RESIDENTIAL ENGINEERING SERVICES, LLC.
SHOP DRAWINGS/SUBMITTAL REVIEW

JOB No.	2701162
DESCRIPTION	SUMMIT HOMES - STONEY CREEK #79 2ND LVL
ADDRESS	1422 SW GEORGETOWN
CITY	LEE'S SUMMIT, MO
DESIGNER	TODD W MOORE
DATE	3/4/2021

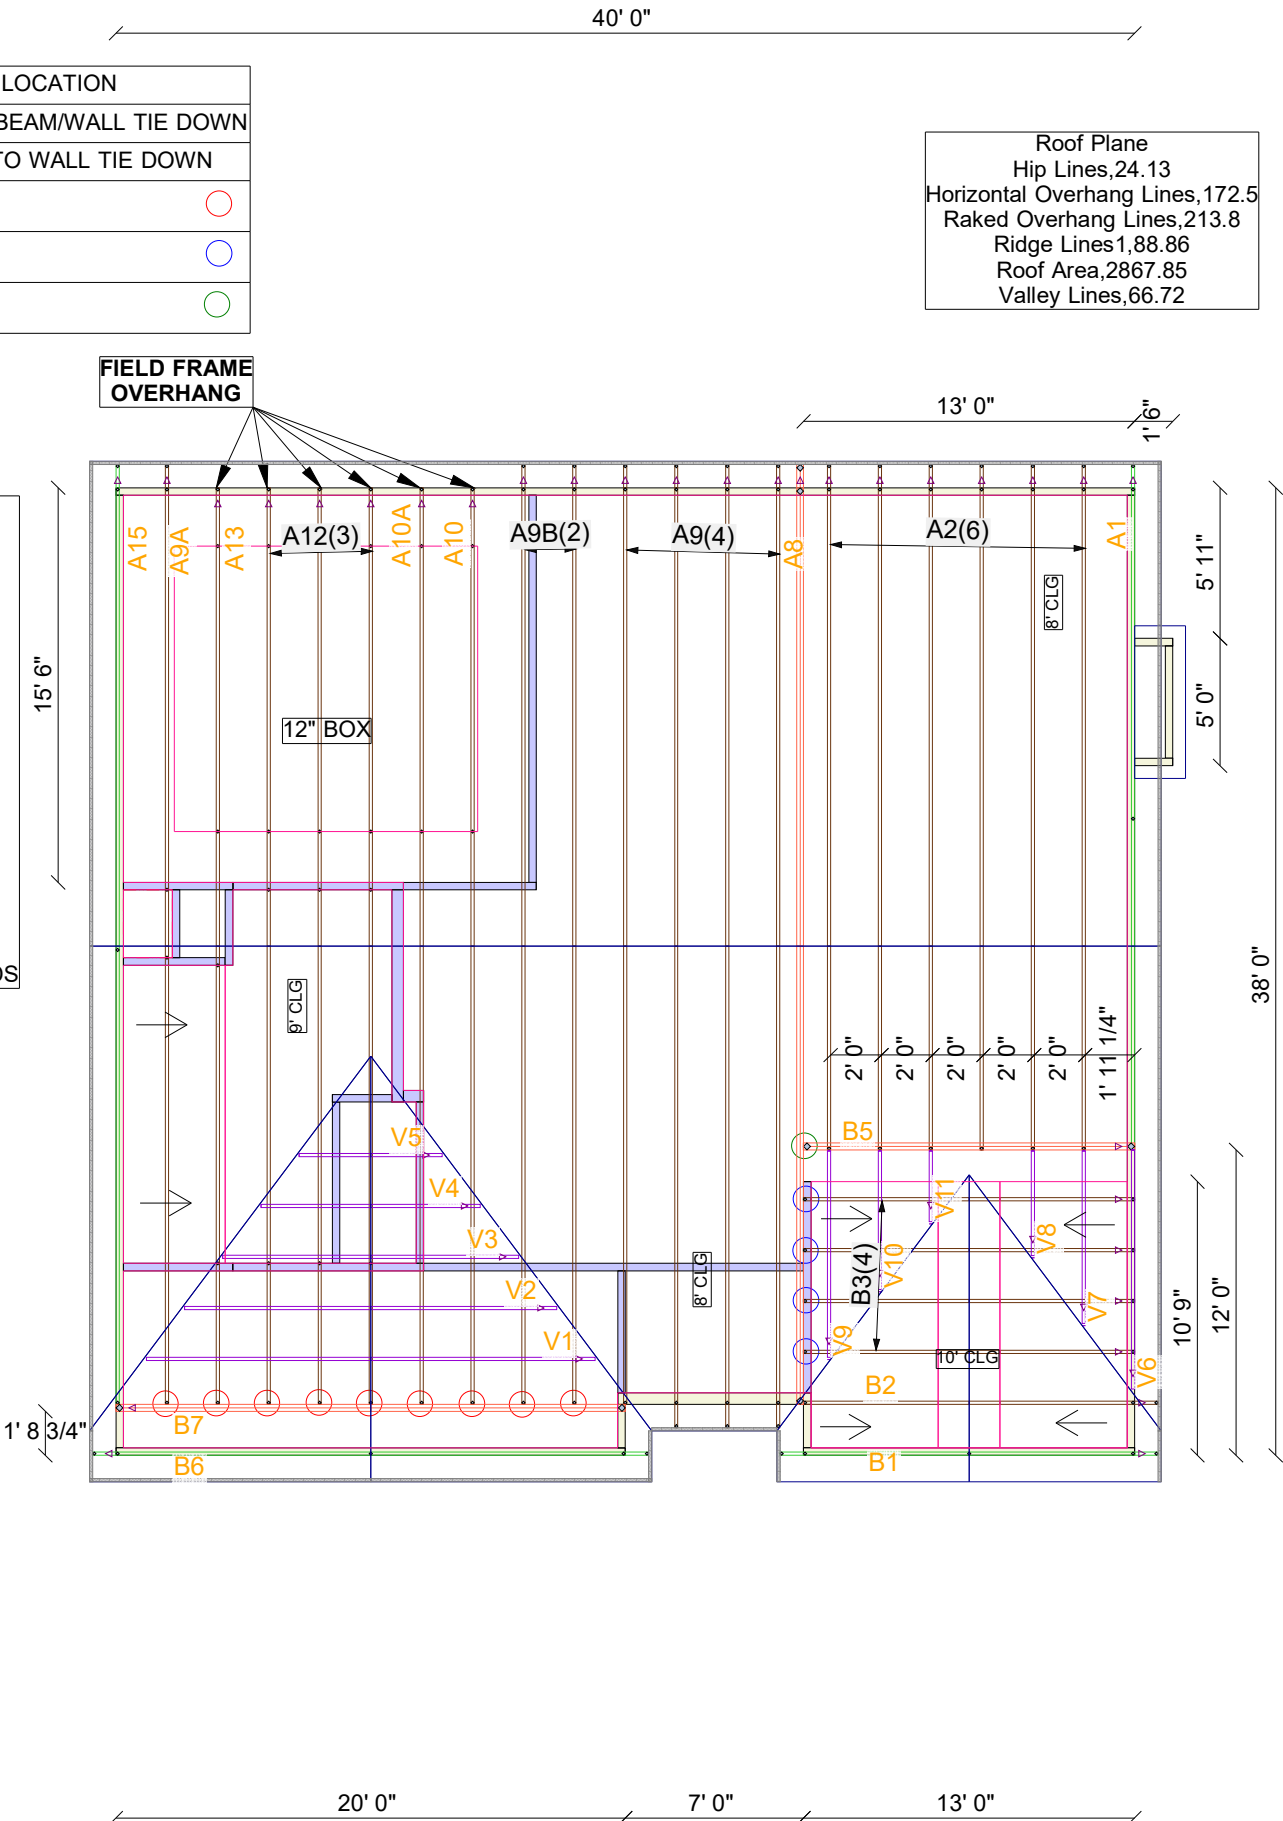
SUBMITTAL WAS REVIEWED FOR DESIGN CONFORMITY AND GENERAL CONFORMANCE TO CONTRACT DOCUMENTS ONLY. THE CONTRACTOR IS RESPONSIBLE FOR CONFIRMING AND CORRELATING DIMENSIONS AT JOBSITE FOR TOLERANCE, CLEARANCE, QUANTITIES, FABRICATION, COORDINATION OF HIS OR HER WORK WITH OTHER TRADES, AND FULL COMPLIANCE WITH CONTRACT DOCUMENTS.

APPROVED
